Service information

Reference no.: SDA_105510

Improvement of the gap between the side panel and the front panel on Granbaristo

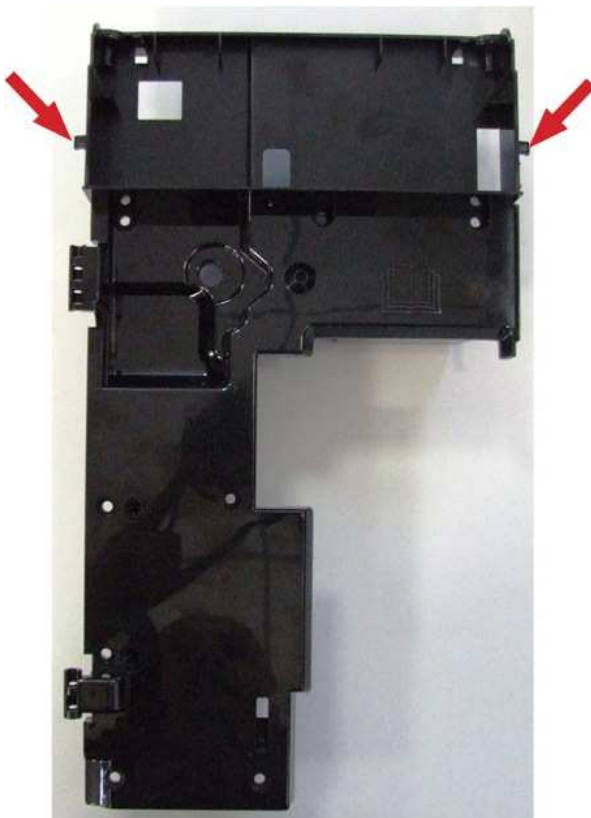
The display support was changed by inserting two hooks to improve the gap between the side panel and the front panel. See Picture 1

Cure

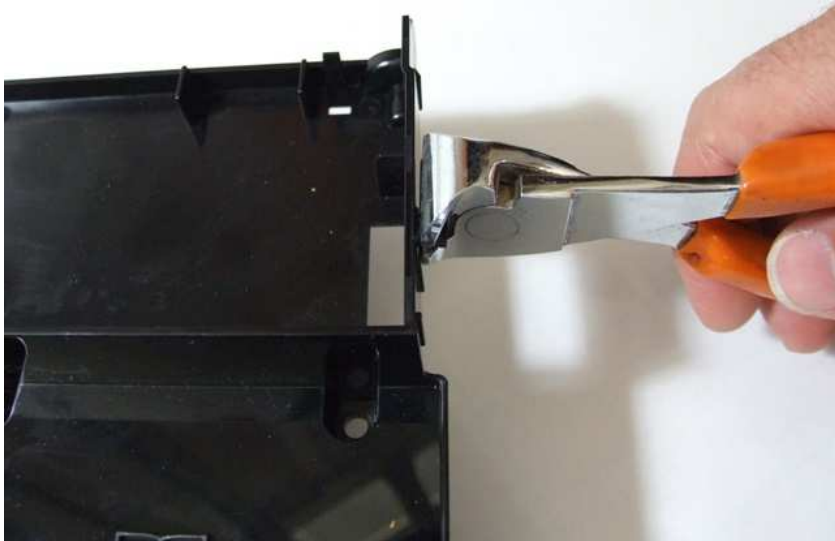
The side panels assembled in the previous machines are not compatible with the new support. To use the new display support on the machines up to TU901419067670 it's necessary to remove the two hooks as shown in Picture 2 and 3.
